City of Granite City

October 4, 1991

SUBJECT: NL/TARACORP SITE - REMEDIAL PLAN - WELL LOCATION

FIG. NO.
6

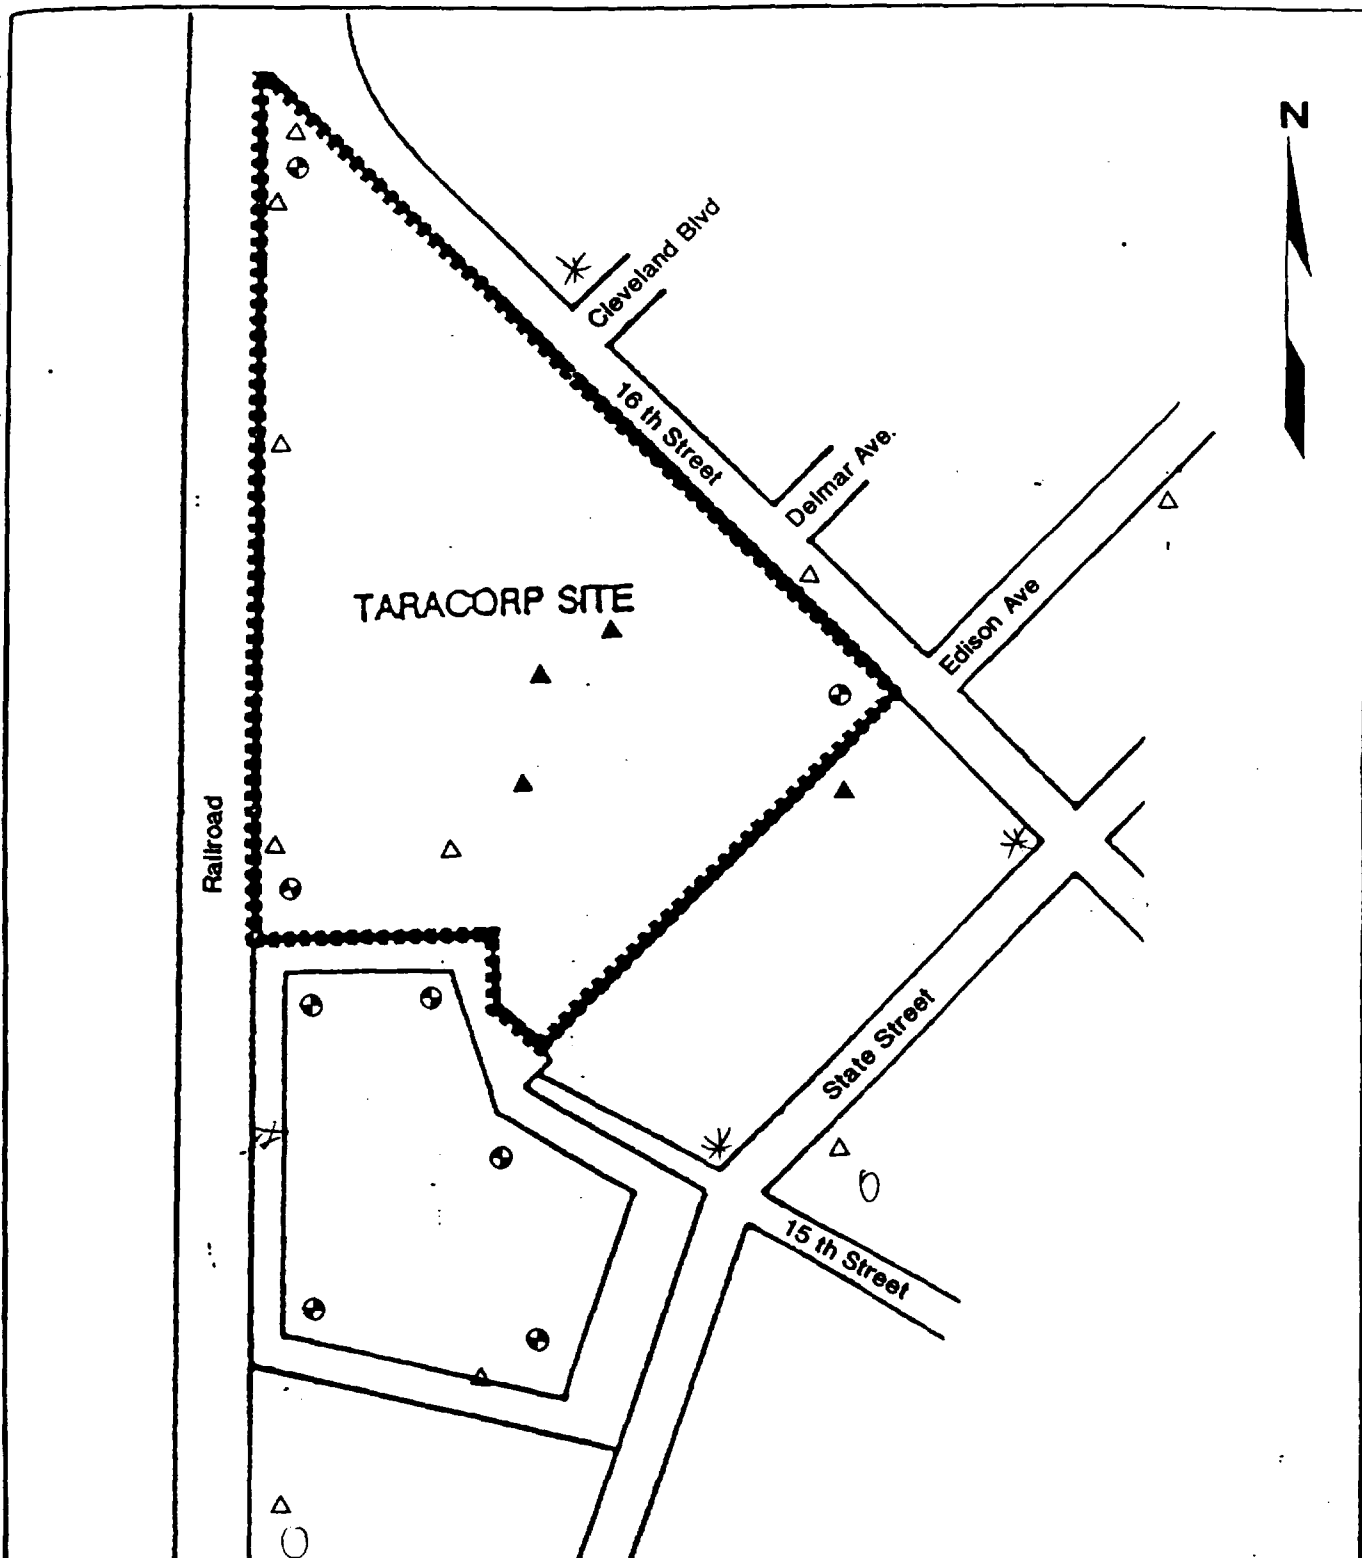
Whereas the subject plan provides for several borings, the marginal expense for lead testing at intervals of 1 1/2 feet between 10 and 20 feet of depth would be minimal. It would be most informative to take seepage groundwater grab samples at the top of the groundwater aquifer to determine what the localized contamination level is. Normal sampling is performed from a deep well with a screen located much deeper than the groundwater surface. The sampler is also purged. Both of these factors preclude an accurate measure of localized groundwater contamination.

The chosen locations are too few, too close to the pile, and poorly distributed. Recommended soil from geotechnical borings and proposed wells be sampled at 1 1/2 foot intervals from 10 to 20 feet deep. Also recommend that at a minimum, four additional deep well borings be made at: Cleveland and 16th Street, State and 16th Street, State and 15th Street, and on the West edge of the SLLR site. These are minimal measure suggested to optimize your proposed efforts.
